ASSESSMENT AGAINST ADG & DCP

State Environmental Planning Policy (SEPP) No. 65 – Design Quality of Residential Apartment Development

Figure 1: Extract of the North Elevation showing the sleeved car parking levels facing the M2 Motorway.

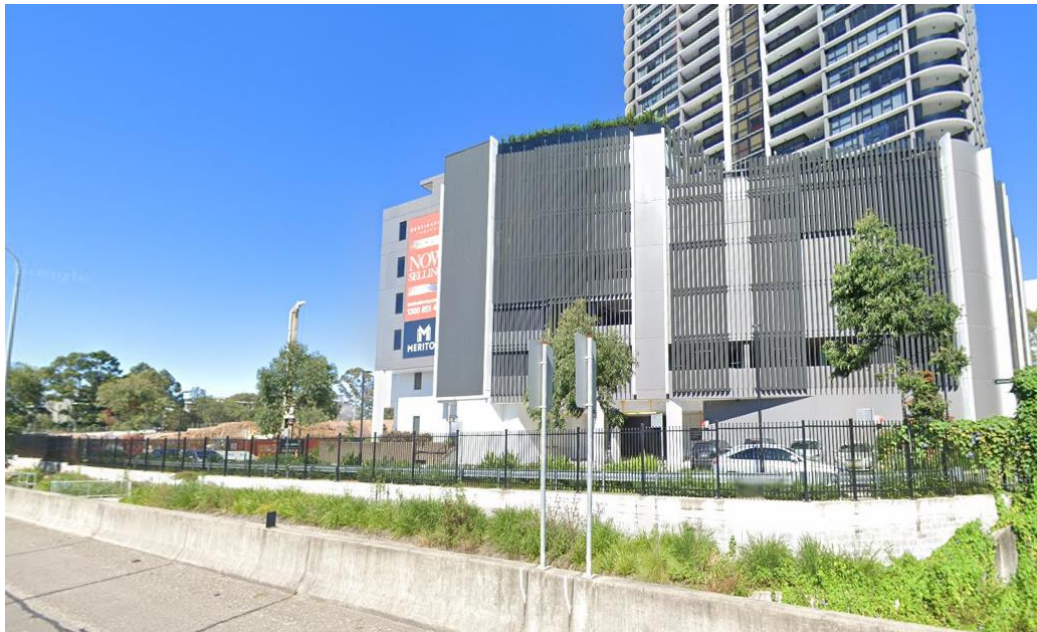
2. Built form & scale	<p>Good design achieves a scale, bulk and height appropriate to the existing or desired future character of the street and surrounding buildings.</p> <p>Good design also achieves an appropriate built form for a site and the building's purpose in terms of building alignments, proportions, building type, articulation and the manipulation of building elements.</p> <p>Appropriate built form defines the public domain, contributes to the character of streetscapes and parks, including their views and vistas, and provides internal amenity and outlook.</p>	<p>The site planning and massing of the proposal, with a 5 storey podium structure and 3 towers results in a built form which complements the transitioning character of the area.</p> <p>The tallest tower (Building C) addresses the intersection of Talavera and Herring Road, where it is stepped over an 'Arrival Plaza' which creates a distinct entry into the site from the intersection.</p> <p>The Building A lobby is located on the eastern corner of the site and is accessed from the pathway from the corner of Herring and Talavera Road. Clear visibility to this lobby is maintained through the articulation of this elevation and wider pathways and open spaces along the eastern boundary.</p> <p>The entry to Tower B is clearly visible and identifiable from the corner of Talavera Road and the through site link.</p> <p>A retail space (with an option for multiple retail tenancies or 1 large retail tenancy) is provided along the Talavera Road frontage.</p> <p>The elevation facing the M2 Motorway includes a sleeved car park which is partially above ground, which is not dissimilar to other developments, including Stage 1, along the M2.</p> <p>The built form, height and scale of the proposed development have been resolved by a thorough evaluation of the site's surrounding context, topography and environmental characteristics, with an emphasis on amenity for future residents. Specific consideration was also given to ensuring appropriate building separation is provided.</p>
